300 West Sandtown Road  
A MASTER PLANNED RESIDENTIAL SINGLE FAMILY COMMUNITY  
BLAKE PROPERTIES INC  
1354 JACKSON CREEK DRIVE  
MARIETTA, GEORGIA 30068  
CENTRAL OFFICE: 770-451-9457  
PHONE: 770-451-9457

REZONING SITE PLAN  
SCALE: 1" = 60'  
DATE: April 12, 2013  
PROJECT: 13072.00  
SHEET TITLE: REZONING SITE PLAN  
SHEET NO.: 1 OF 1  
DATE PLOTTED: 4/12/13 10:58 AM  
DRAWN BY: J. G. GARDNER  
CHECKED BY: J. G. GARDNER  
DATE CHECKED: 4/12/13 10:58 AM

# Z-33

**ZONING COMMENTS:**

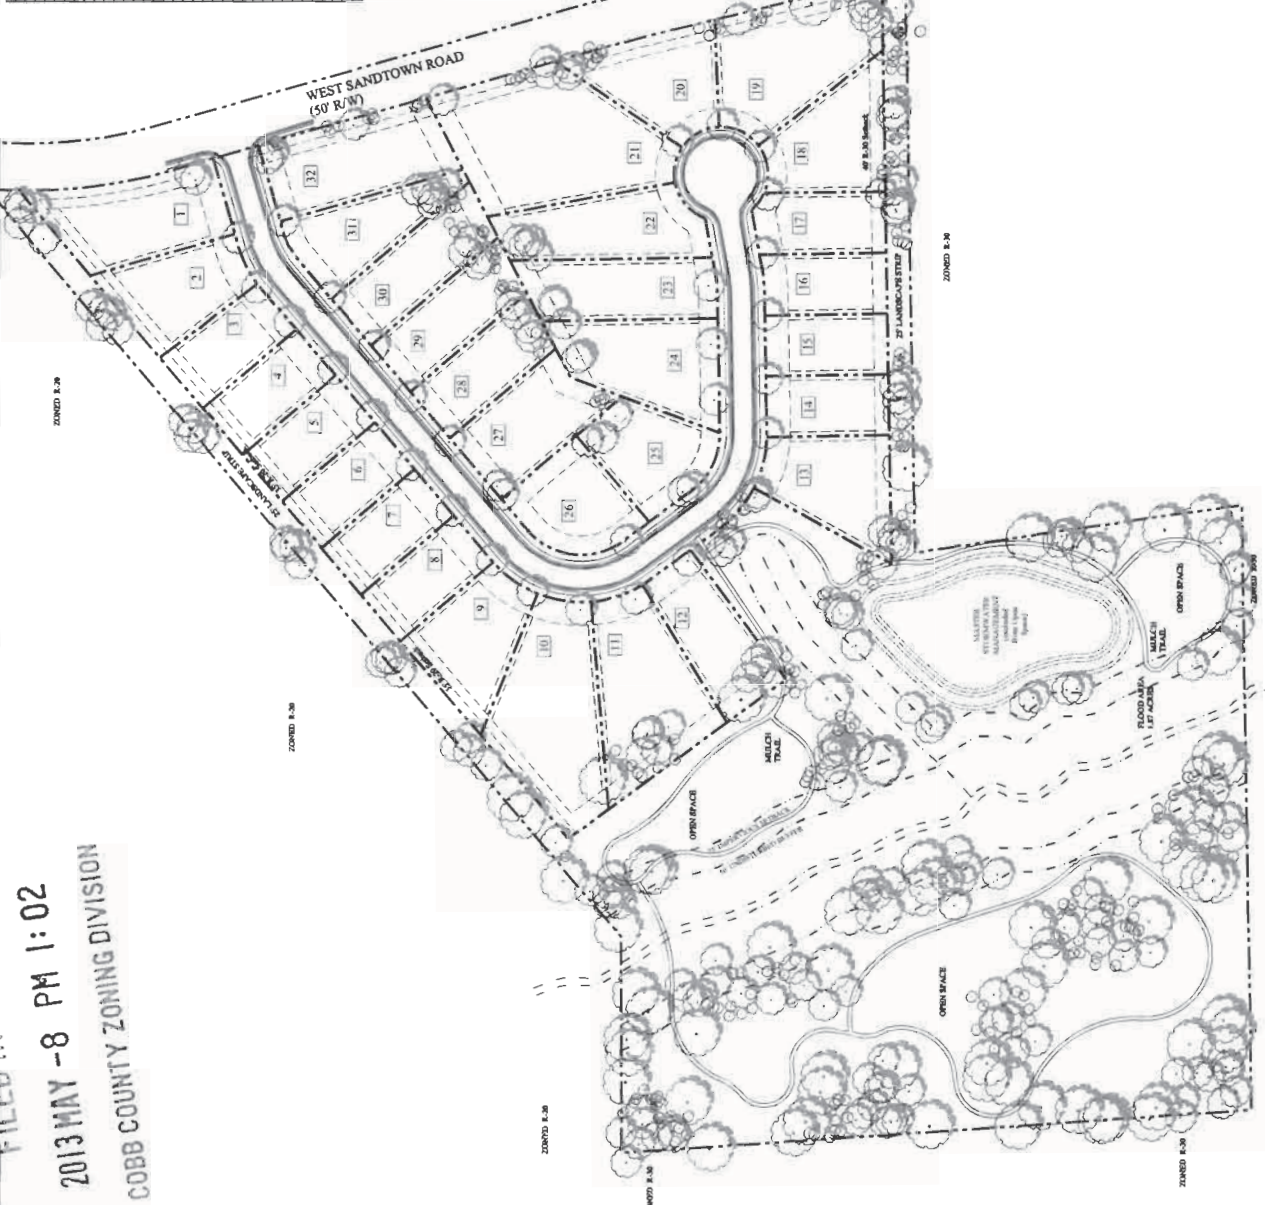
1. Precedent has been set that in this area of the county lots within OSC communities have not been smaller than 10,000 square feet. Staff recommends increasing lots 3 through 7 and 14 through 17 to greater than 10,000 square feet.

2. Applicant should incorporate larger lots to the exterior of development and design smaller lots to the interior.
3. As another form of privacy barrier staff recommends installing a 6' high green, black or brown chain link fence between the open space and lots 1 through 12 and 13 through 19.

- Provide comprehensive hydrology/stormwater controls to include development of out parcels.
- Submit all proposed site improvements to Plan Review.
- Any **spring activity** uncovered must be addressed by a qualified geotechnical engineer (PE).
- Structural fill placed within the existing lake bed must be performed under the direction of a qualified registered Georgia geotechnical engineer (PE).
- Existing facility.
- Project must comply with the Water Quality requirements of the CWA-NPDES-NPS Permit and County Water Quality Ordinance.
- Water Quality/Quantity contributions of the existing lake/pond on site must be continued as baseline conditions into proposed project.
- Calculate and provide % impervious of project site.
- Revisit design; reduce pavement area to reduce runoff and pollution.

- No Stormwater controls shown \_\_\_\_\_
- Copy of survey is not current – Additional comments may be forthcoming when current site conditions are exposed.
- No site improvements showing on exhibit.

1. This site is located just west of West Sandtown Road on an unnamed tributary to Mud Creek. The entire site drains to creek which bisects the western half of the site. There is a small existing farm pond (~1/3 acre) located near the center of the site.
2. The proposed plan shows the elimination of the existing farm pond. The water quality benefit and storage effect of the existing pond must be recreated in the proposed stormwater management facility.
3. A footbridge across the creek is proposed to provide trail access to the open space area to the west of the stream. A hydraulic analysis will be required to provide an no-rise certification for this structure. No approach fill within the floodplain will be allowed.
